Ref: 310200185

Auckland Regional Landfill, Section 92 Response

Stantec is pleased to formally provide the following response to the traffic comments received from Auckland Council, dated 18 September 2019, in respect of the above project.

POLARIS ACCESS ASSESSMENTS
 DOME VALLEY, SH1
 PROPOSED ROUNDABOUT
 VEHICLE TRACKING

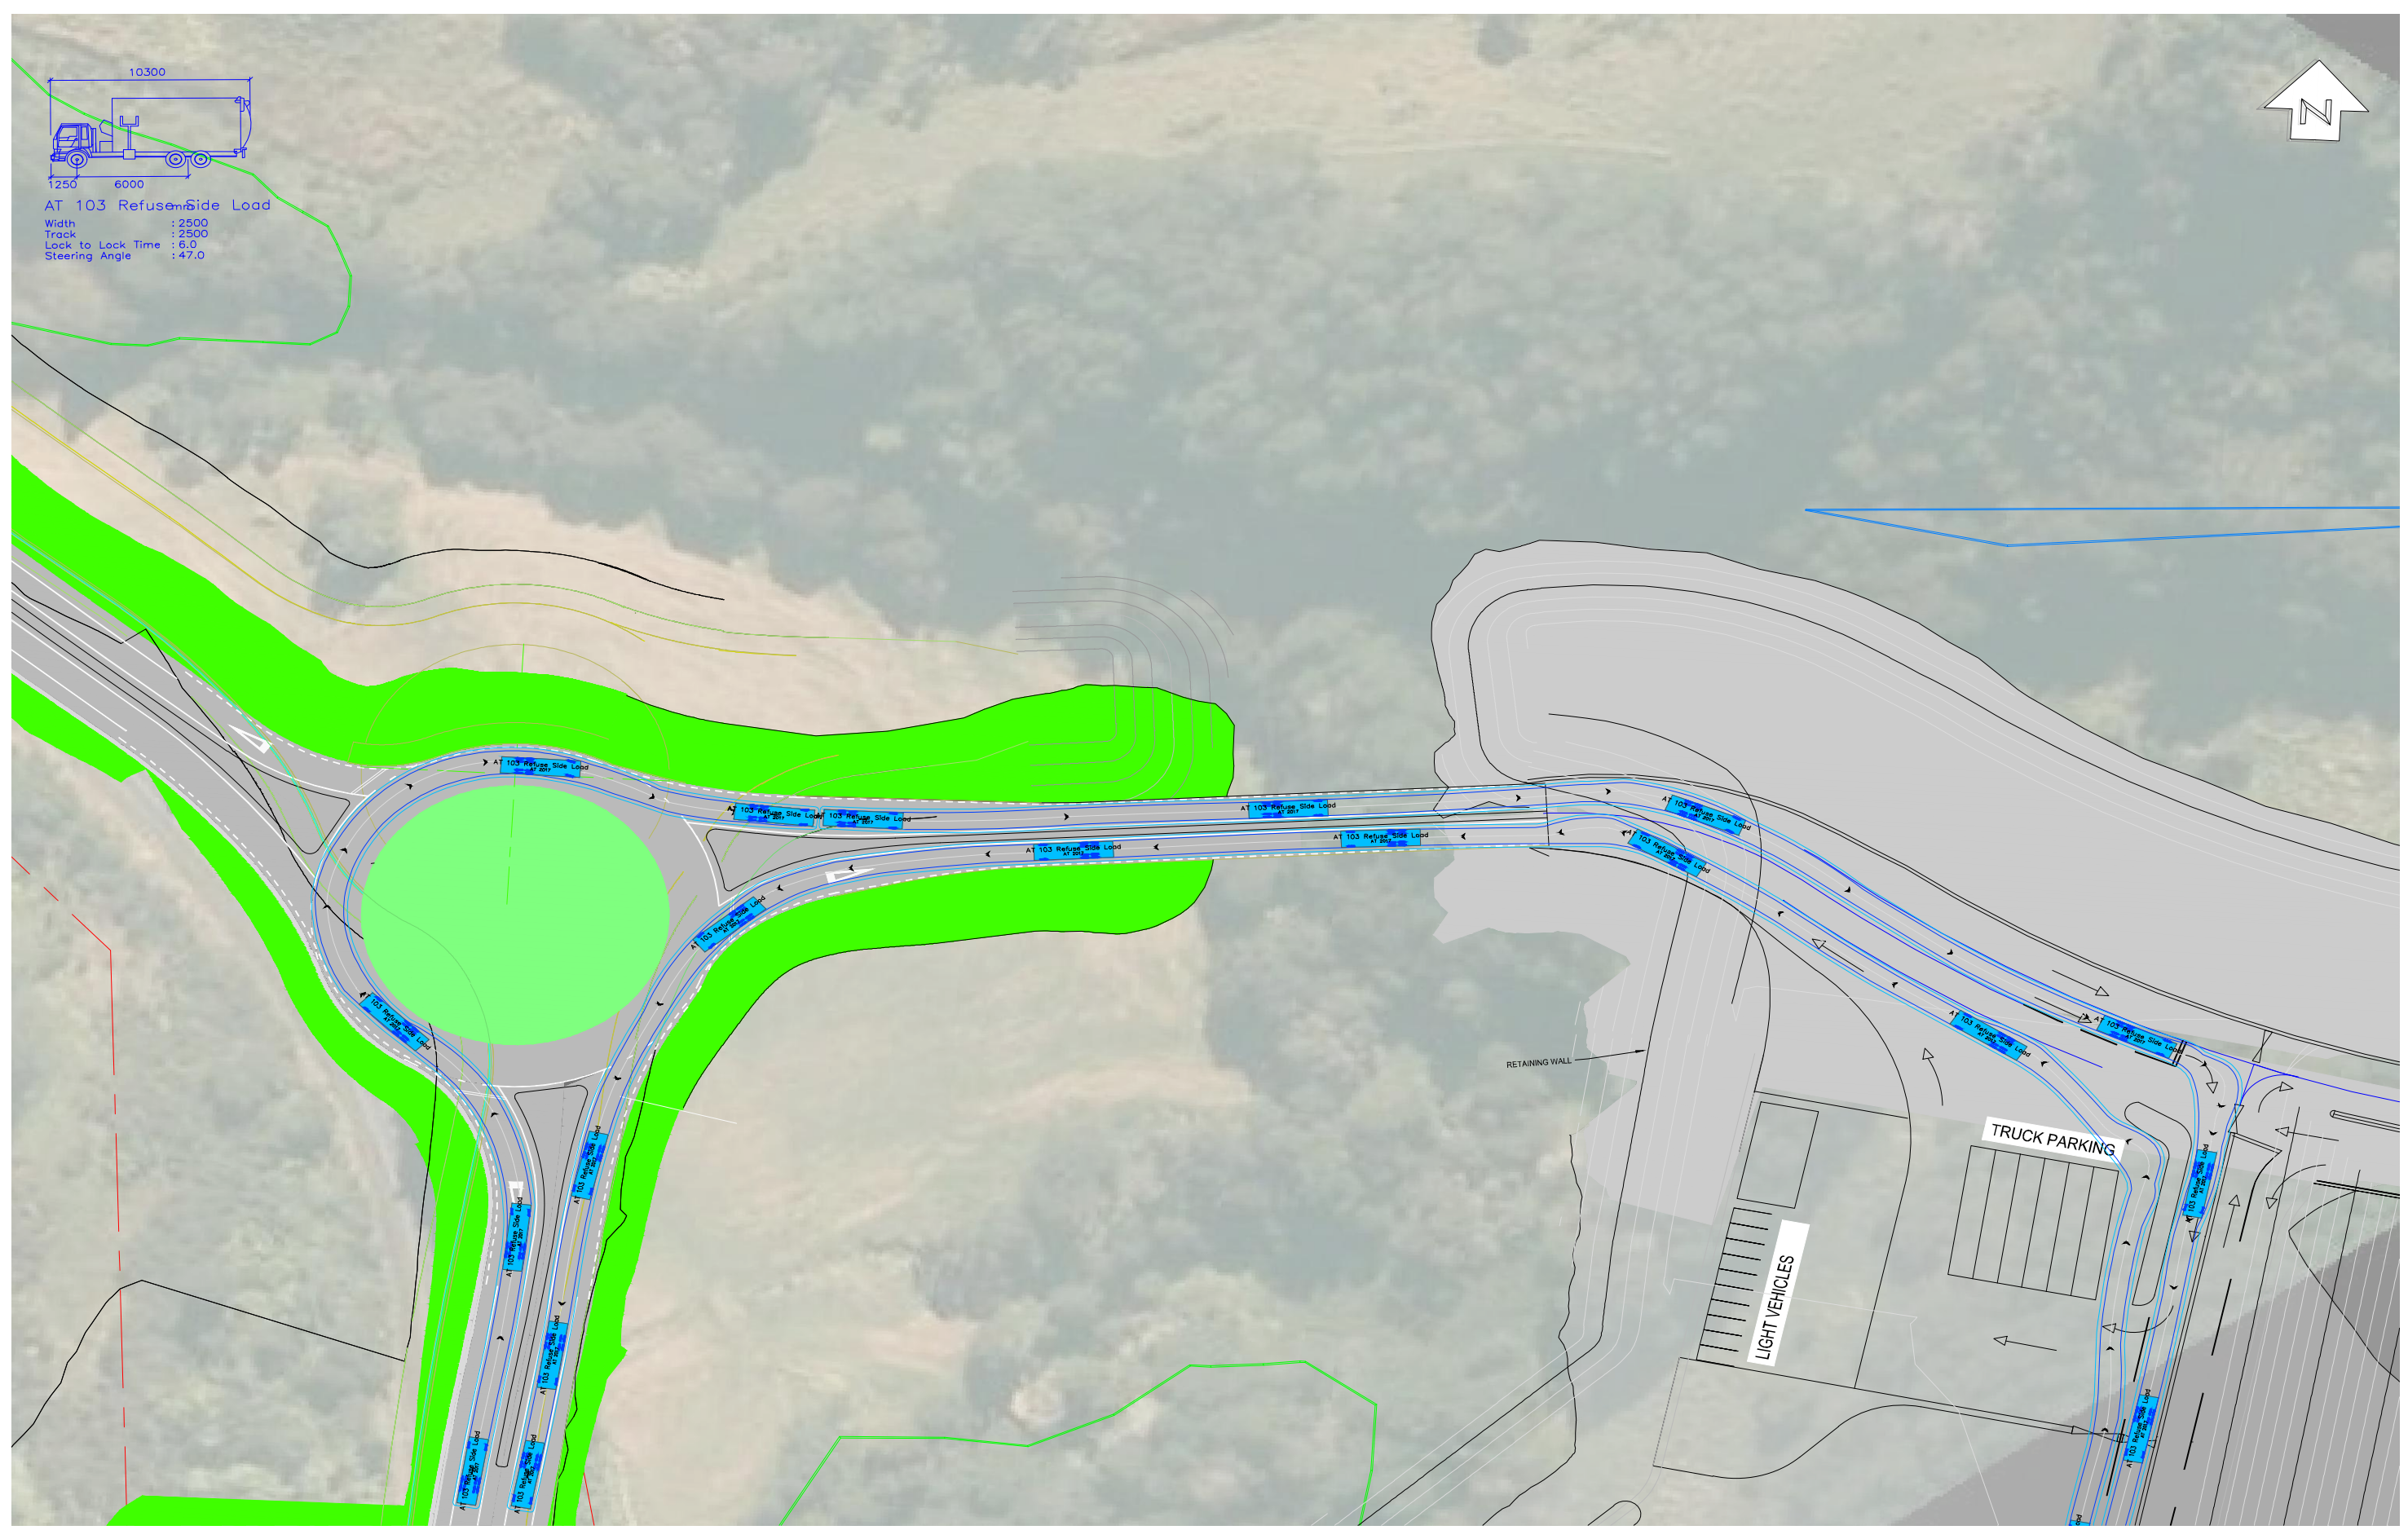
"Please provide truck tracking diagrams to show access to and from the roundabout and bin storage area to demonstrate that sufficient area is available to accommodate all required truck activity on site."

Truck tracking curves showing truck access to and from the roundabout to the Bin Exchange Area are demonstrated in the attached **Figure 1**.

The tracking curves demonstrate that sufficient space is provided at the connection between Landfill Access Road and the bin exchange area to accommodate truck movements, and that no manoeuvrability issues are expected. The detailed design of this area will be confirmed the detailed design stage and the approval of the overall roundabout and weigh-bridge access design will be subject to approval by NZTA.
